Licence to Interfere by Impounding Flow

HAZARDOUS WASTE DAM

SUBJECT: Repeal of Licence 52629

SITE NAME:- "DISUSED TAILINGS DAM"

Figure 2- Dissolved Tailings Dam  
Proposed Rehabilitated landform

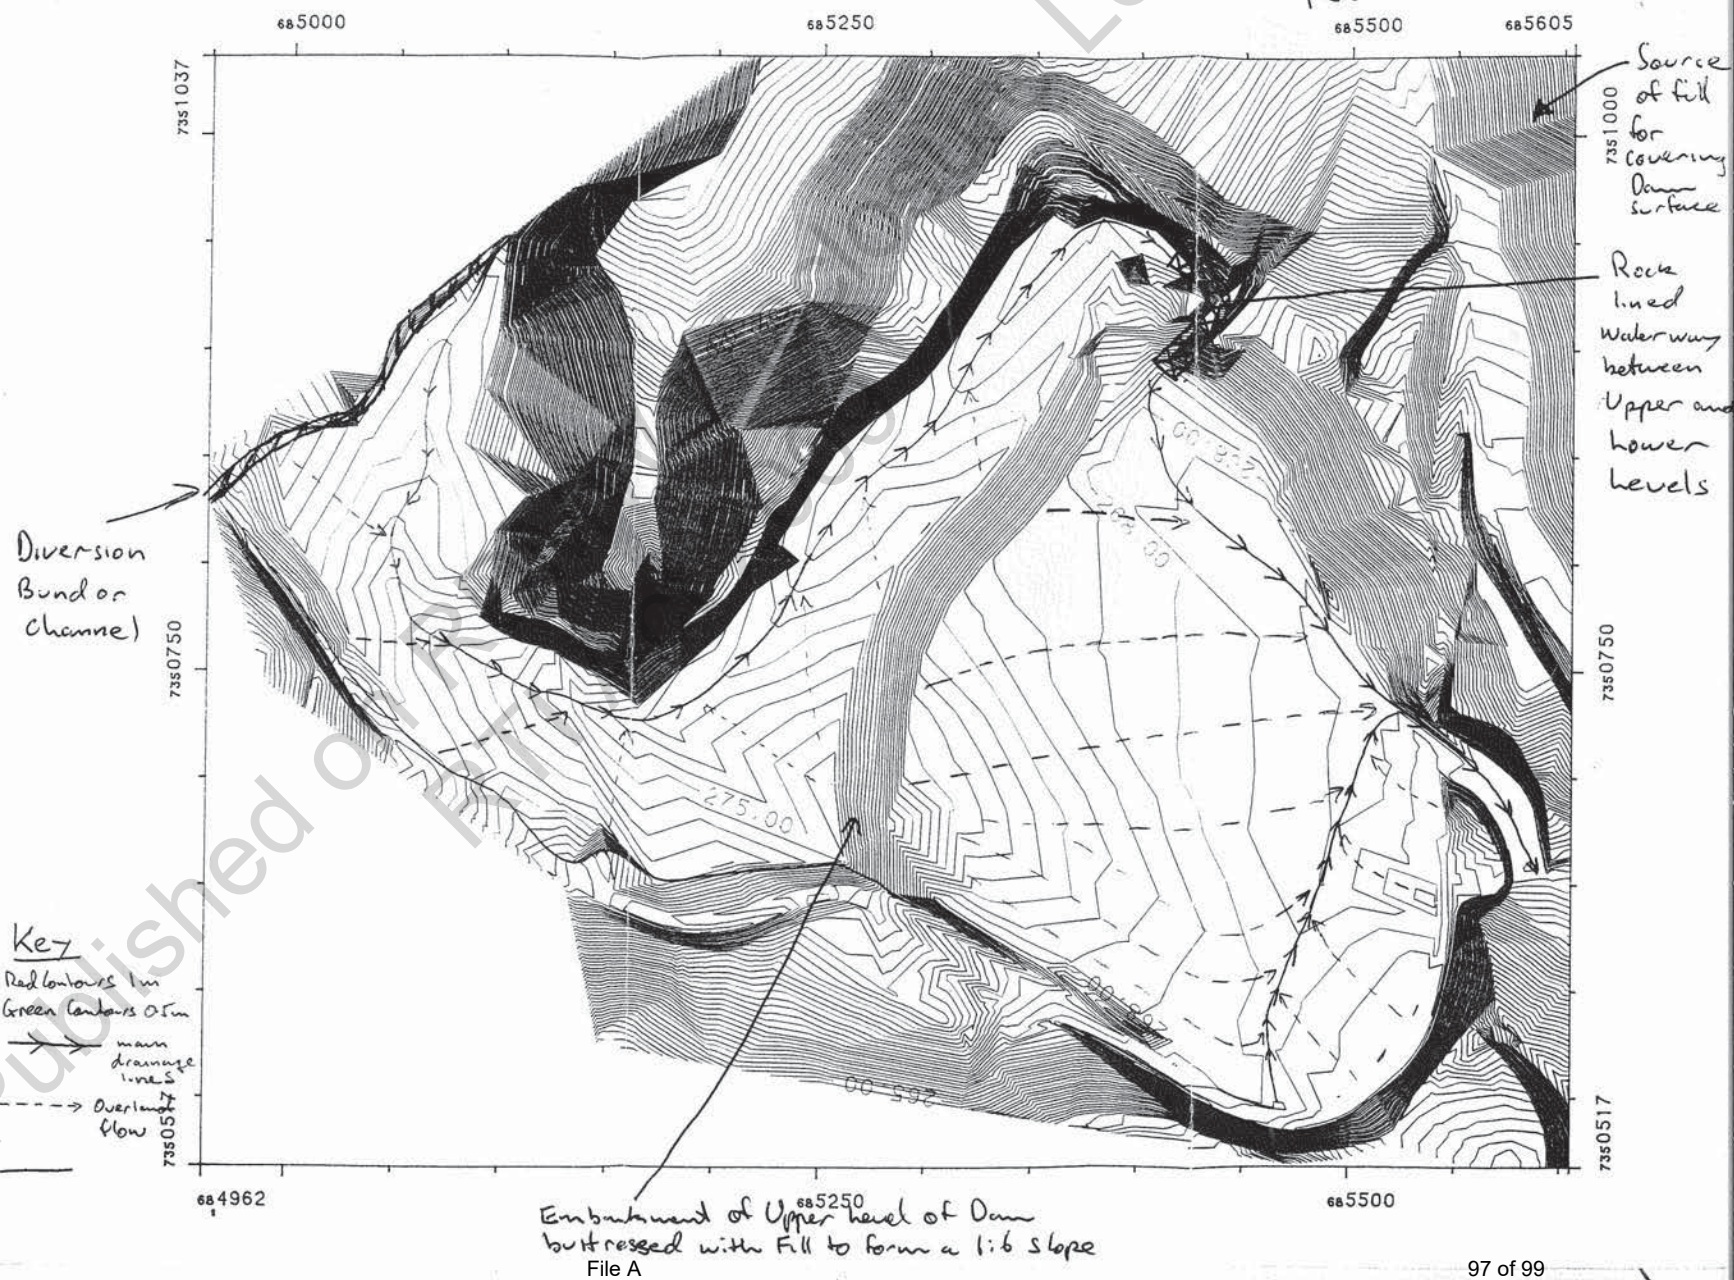
Figure 2 shows the proposed final rehabilitated landform for the both levels of the dams. The design involves the placement of 1 to 1.5m of spoil over the tailings so that all water runoff from the new surface will flow out the existing spillway without any ponding on the surface. Some minor reshaping of the tailings may be required to achieve a minimum 1m spoil cover. A 1m cover is also required to permit machinery access over the dam surface. The spoil will come from the adjacent Ramp 11 North box cut spoil pile which will be rehabilitated at the same time.

The remainder of the dam surface is designed such that there is a fall of 2 to 5% from any point into the two main drains. The drainage patterns are illustrated on Figure 2. It is proposed to leave the bleeder pipe in place to act as a sub-surface drain to intercept water which may seep through the spoil. Any seepage discharge from the bleeder pipe will collect in a pond some 50m downslope from the pipe. This pond is quite large. Significant rainfall in the catchment area of the pond would be required before it would overflow to Sirius Creek (i.e. There was still over 2m freeboard in the pond after 122mm of rain fell in November 1993). A large dilution capacity is, therefore, available.

Figure 1- Disused Tailings Dam  
Current hand for

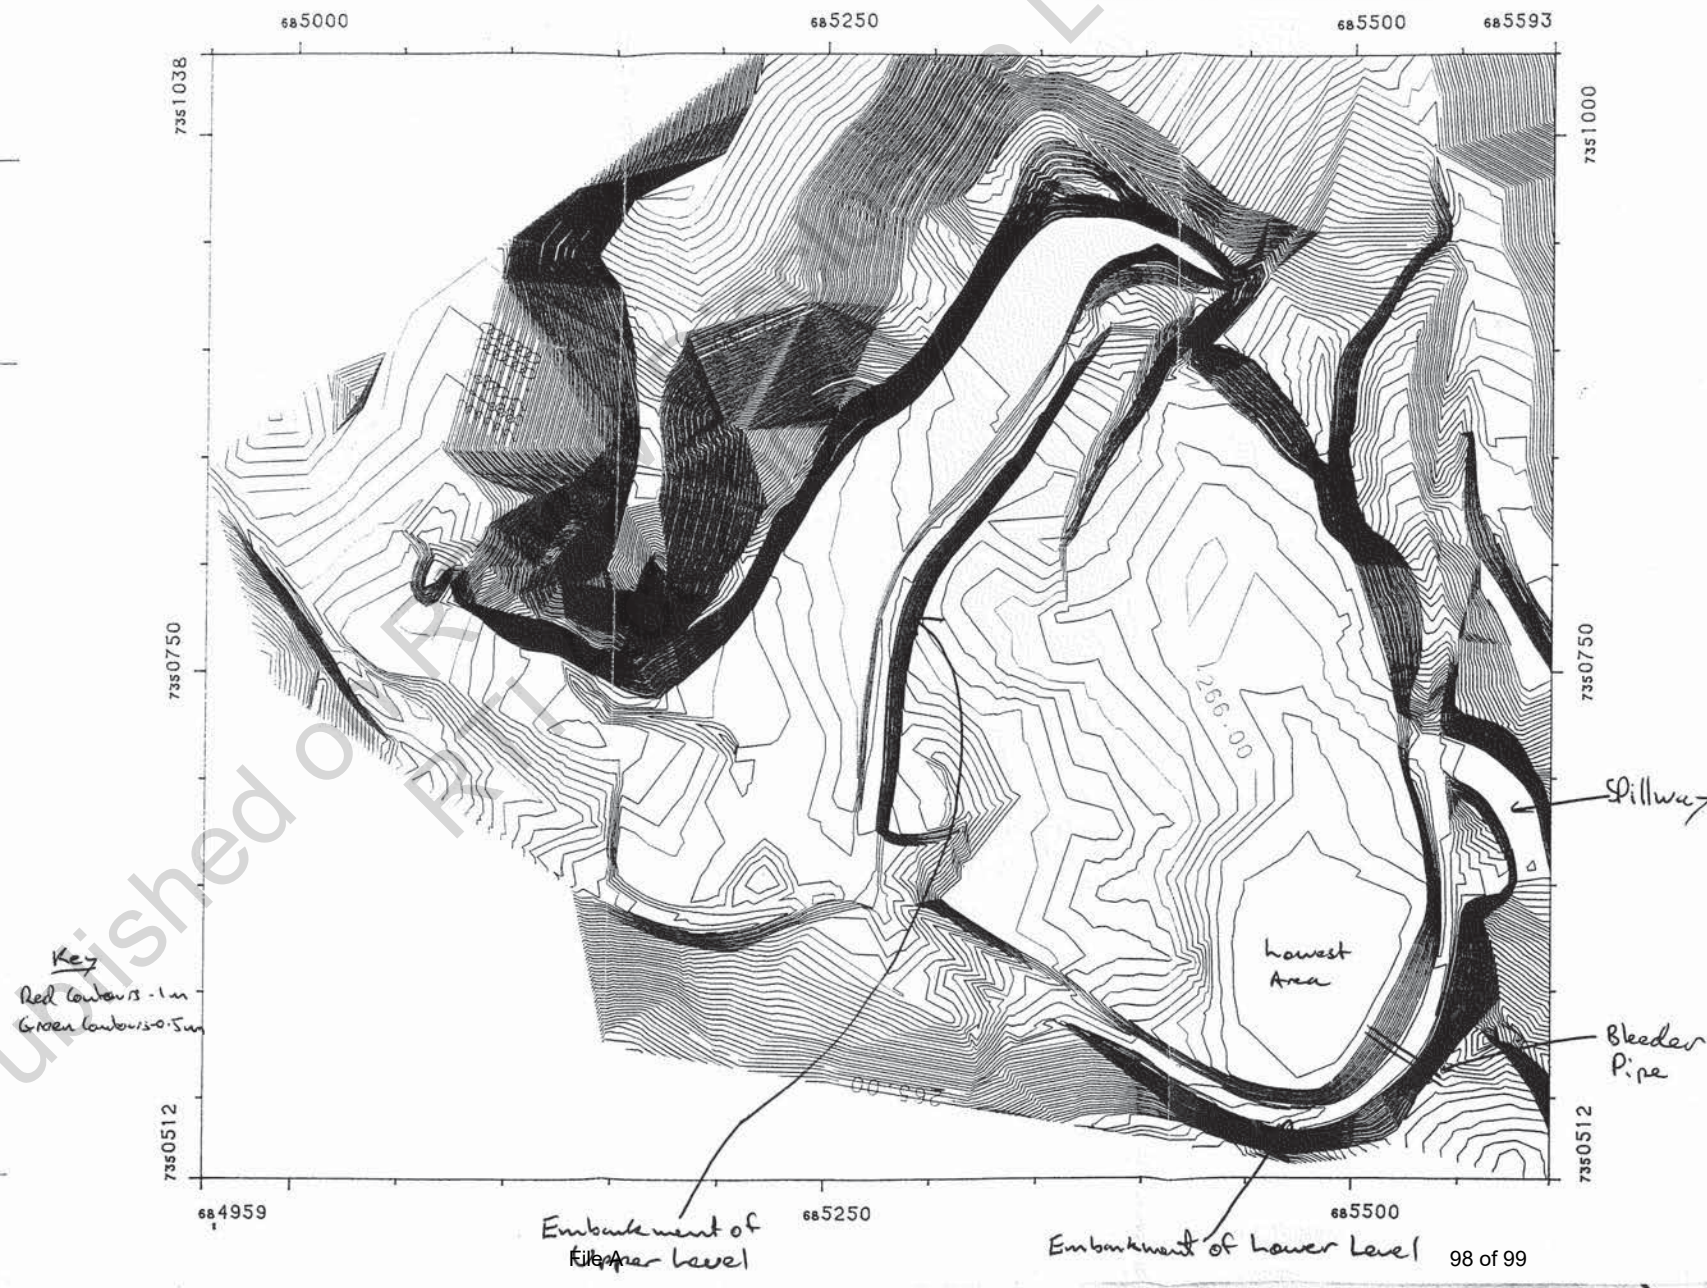
Figure 1 shows the current landform for the Disused Tailings Dam. The area to be rehabilitated consists of an upper and lower level each with an associated embankment. Figure 1 also shows the location of the low level bleeder pipe and the spillway.
